# UNITED STATES PATENT AND TRADEMARK OFFICE

APPLICATION NO.	FILING DATE	FIRST NAMED INVENTOR	ATTORNEY DOCKET NO.	CONFIRMATION NO.
10/667,115	09/19/2003	Russell Norman Mirov	SUN03-0112	8531
57960 7590 07/09/2008 PVF -- SUN MICROSYSTEMS INC. C/O PARK, VAUGHAN & FLEMING LLP 2820 FIFTH STREET DAVIS, CA 95618-7759				
EXAMINER				
DINH, TUAN T				
ART UNIT		PAPER NUMBER		
2841				
MAIL DATE		DELIVERY MODE		
07/09/2008		PAPER

### Office Action Summary

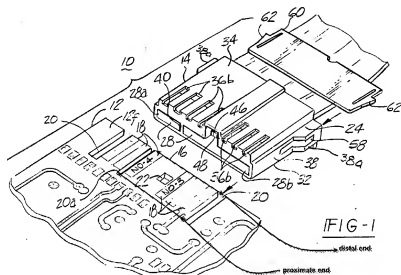
As to claims 1-3, Matson discloses a circuit board (12, column 2, line 7) as shown in figures 1-2 comprising: a substrate which includes a specified area of the substrate that is used as a mechanism (16, column 2, line 9) comprising:

signal means for (wire traces 18, and circuitries formed in/on the circuit board 12) conducting a signal between the mechanism (16) and the circuit board (12); and

separation means (gaps 20, column 2, line 15) for facilitating detachment of the mechanism (16) from the circuit board (12) wherein the mechanism (16) is configured to be detached by breaking the substrate at the specified area (the mechanism adapted to be broke then the circuit board being broke then the circuit board cannot be used anymore);

identification means for (labels No.1-No.6, figure 1 shows the label No.3 and No.4) identifying the mechanism (16);

wherein the circuit board becomes at least partly non-functional if the mechanism is detached from the circuit board.

a circuit board (12) comprising a substrate including **a specified area that is used as a tab** (key tab-16), wherein the tab (the specific area 16) comprising: proximate and distal ends (see figure above); and two opposing sides separated from the assembly by gaps (slots 20); an identification (labels NO.1-No.6 formed on conductor runs 18 to identify the function of leads/pins of the conductor runs) situated on the tab (16); and
